The Town of Hilton Head Island Regular Design Review Board Meeting

Tuesday, January 11, 2011

Town of Hilton Head Island
DESIGN REVIEW BOARD
Minutes of the Tuesday, December 14, 2010 Meeting
1:15pm – Benjamin M. Racusin Council Chambers

DESIGN TEAM/ DRB COMMENT SHEET

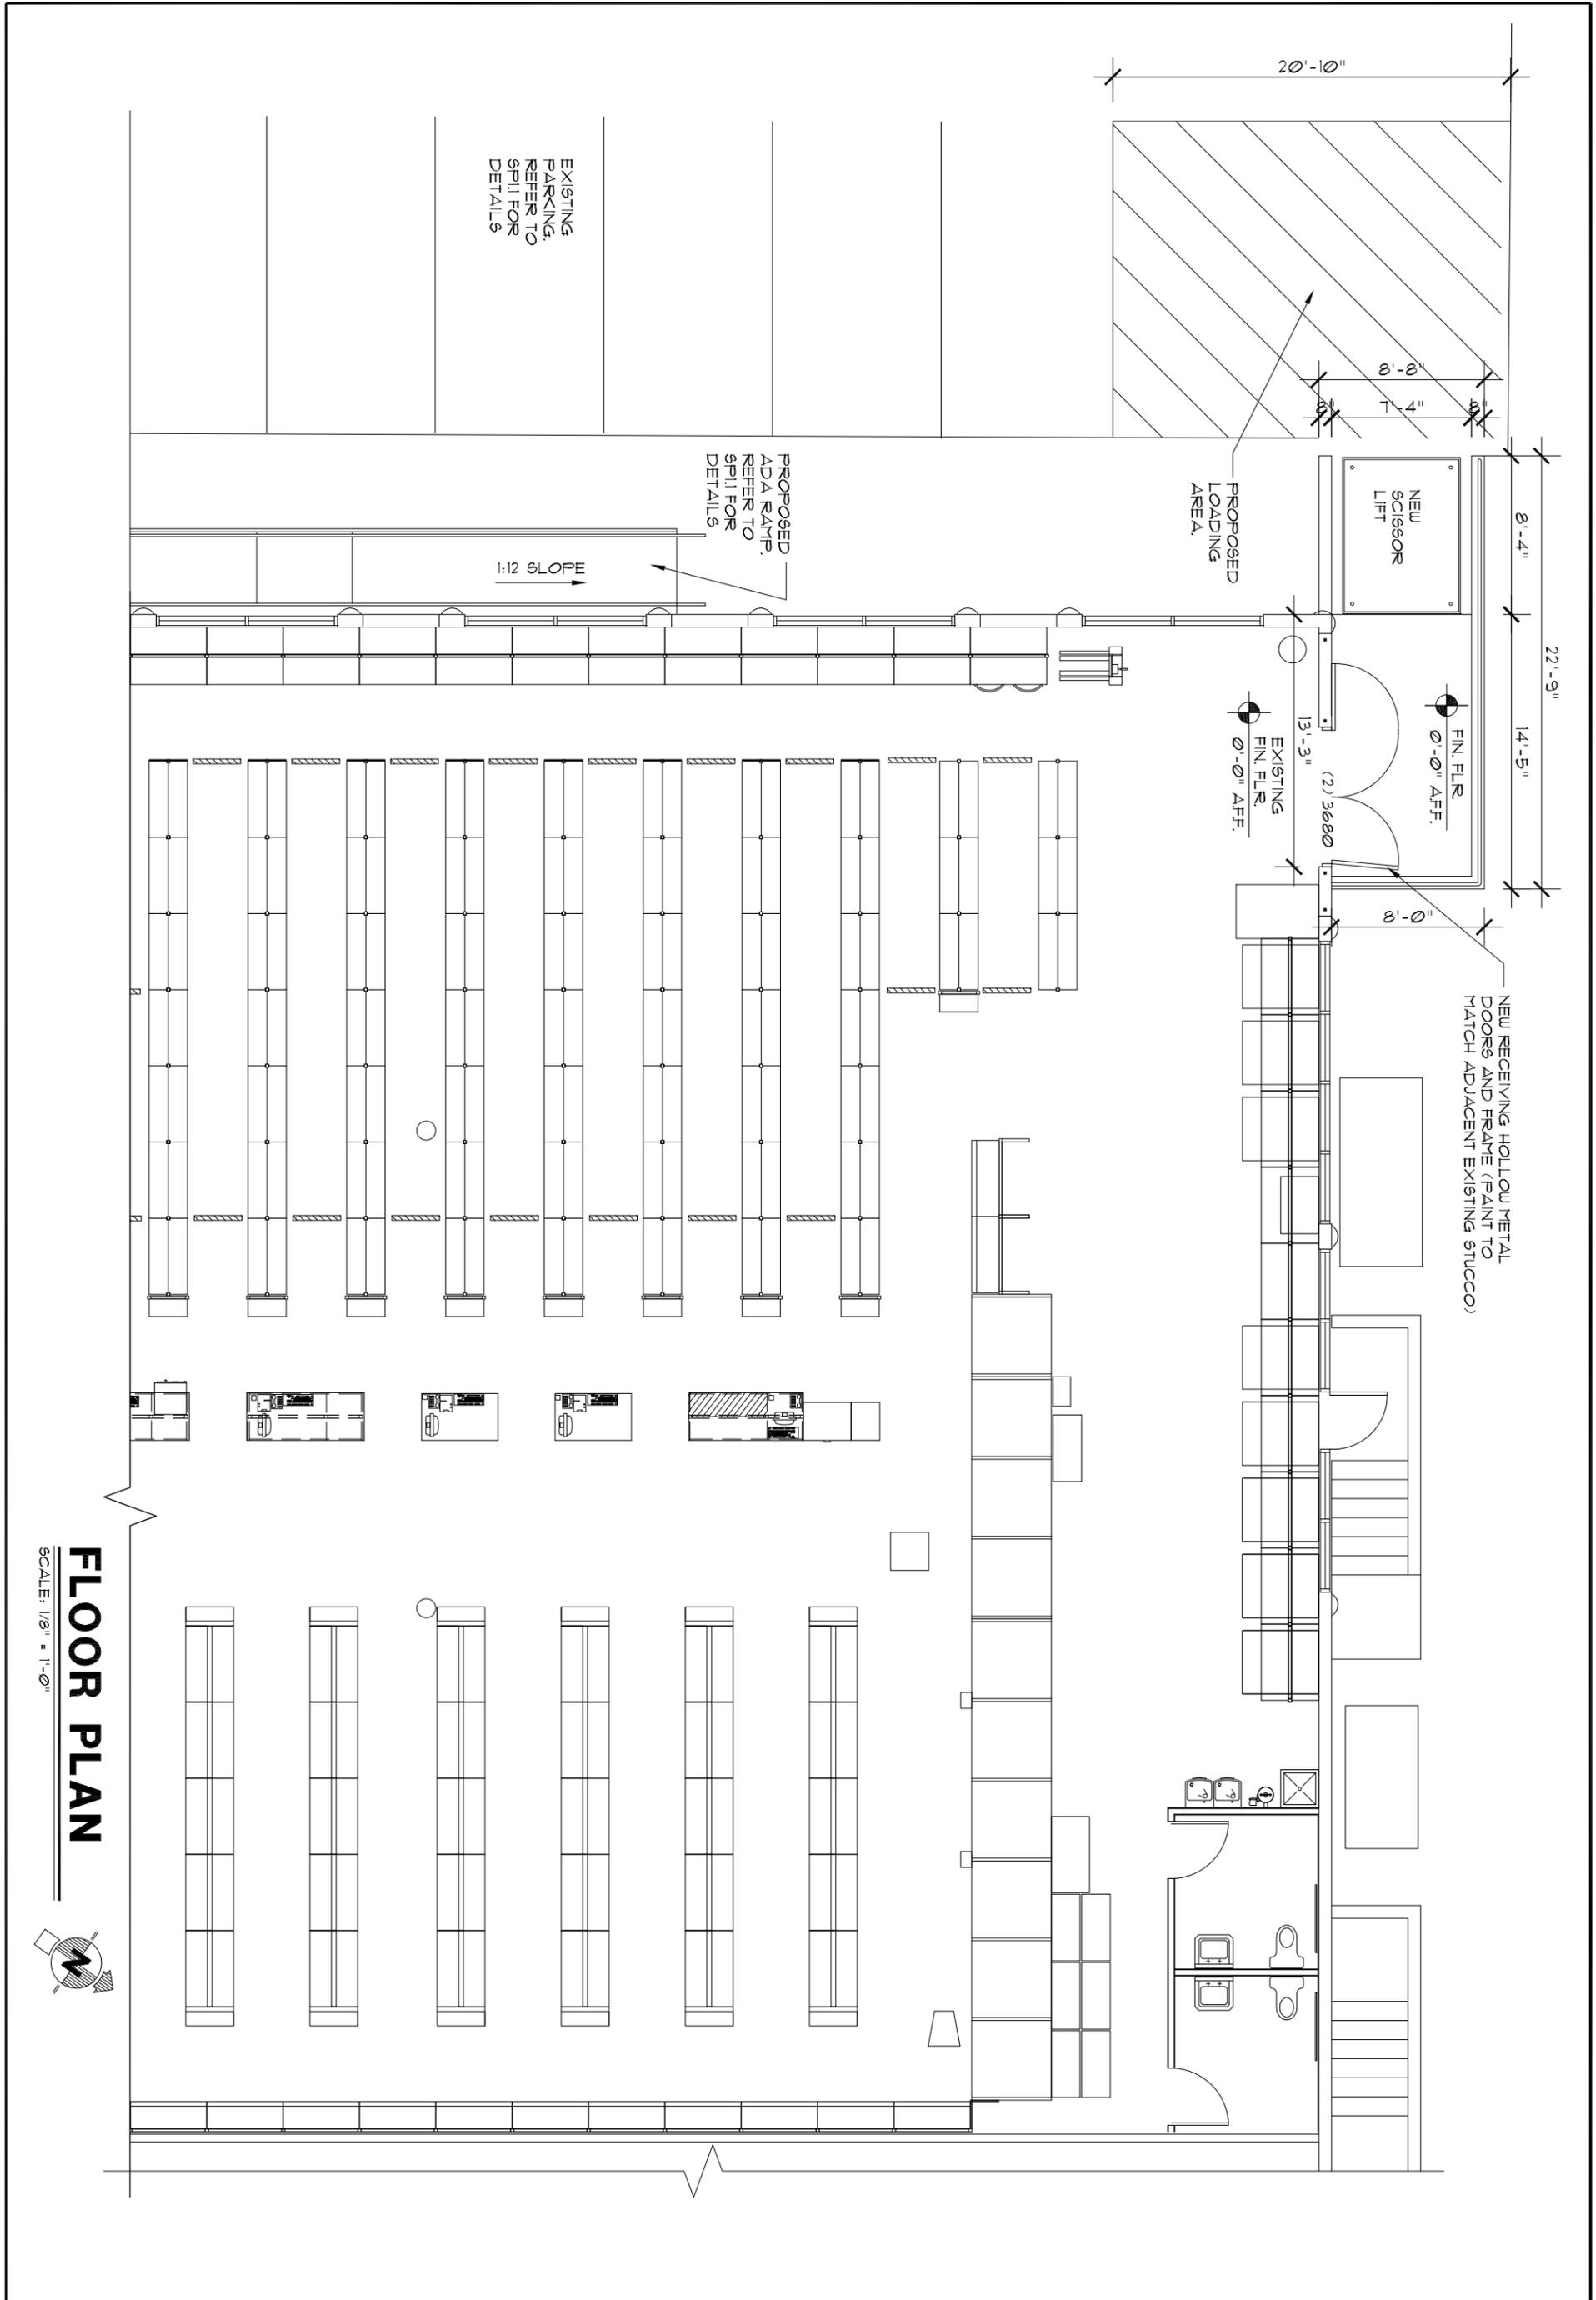
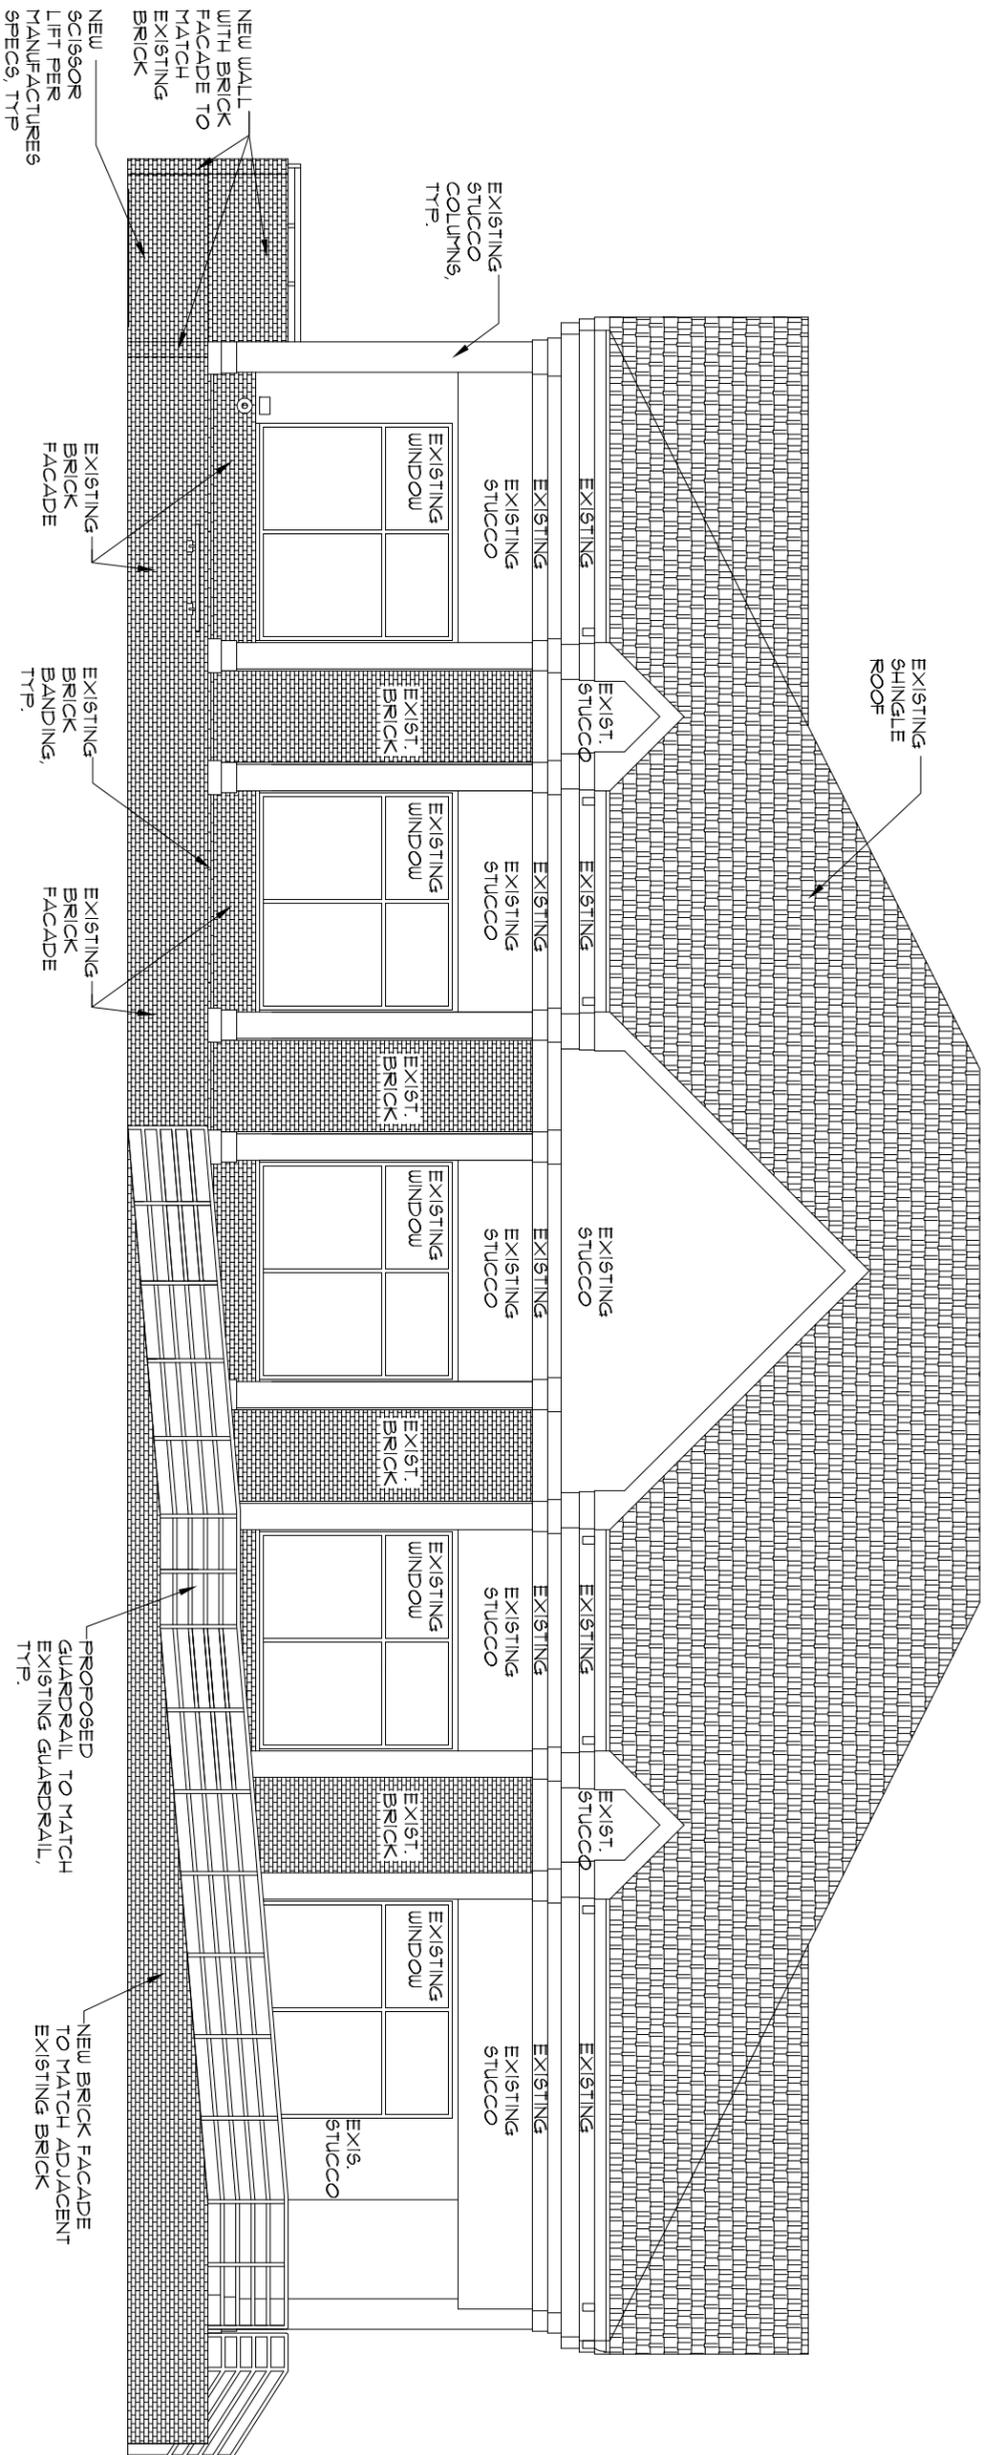
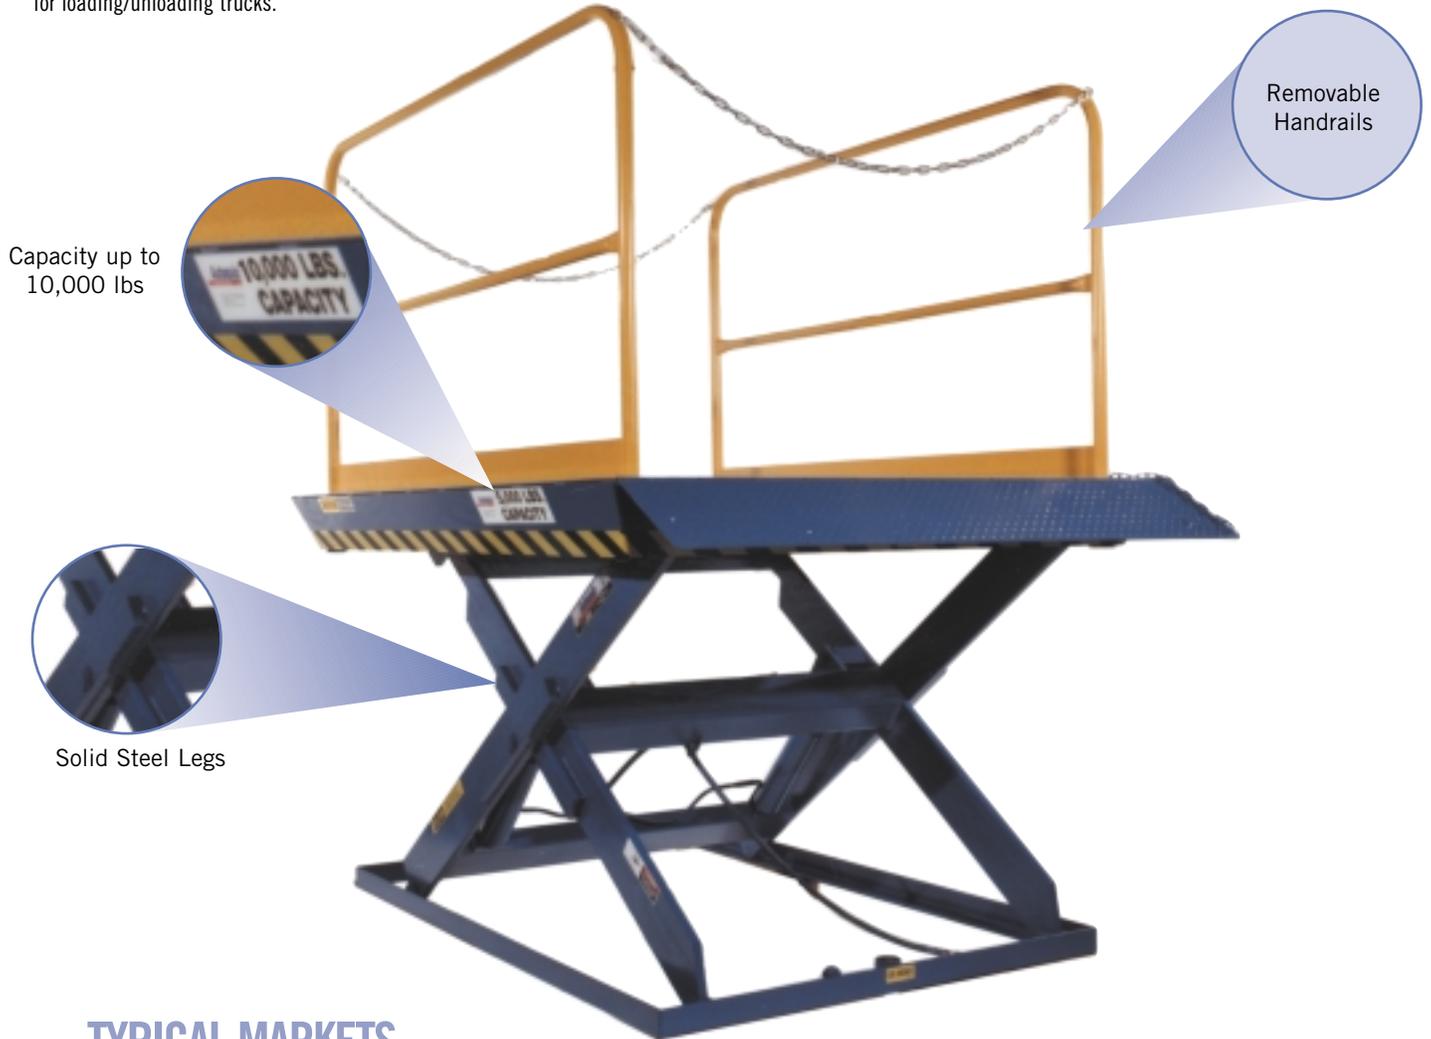
Project proposes removing one set of windows to install doors for delivery, as well as a scissor-lift for inventory, and a new handicap ramp. Materials, colors, and details match those existing on the building. The Board may want to see a detail on the short wall to the south of the new scissor-lift. Most at-grade improvements will be screened from William Hilton Parkway by existing landscaping. Staff is curious how the lift will look when not in use, and how/if it would need to be screened from New Orleans road (if necessary). Staff would recommend the removable handrails on the lift be stored, when not in use.
